REMARKS

Attorney Docket: APTI:027

F16.6

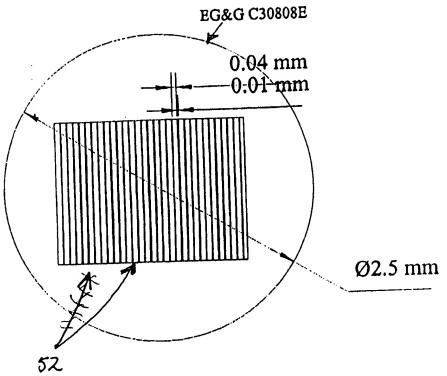
The examiner has raised an objection to Fig. 6 as not being designated as prior art.

Applicant submits that Fig. 6 is not prior art, but instead discloses a modified electrode structure of a conventional device. The examiner is directed to page 8, last two lines, which states: "As shown in Fig. 6, the modified electrode structure 52...." (emphasis added). Applicant notes that original Fig. 6 includes a label EG&G C30808E, which was intended to be directed to the underlying base diode upon which the modified electrode structure 52 is formed. The use of the

modified electrode structure 52, however, is not part of the prior art. Accordingly, Fig. 6 should not be labeled as prior art. A proposed drawing correction is enclosed herewith to include an arrow to the base diode associated with the label. Applicant will submit formal drawings incorporating the proposed drawing correction upon the approval of the examiner and the allowance of the claims in this case.
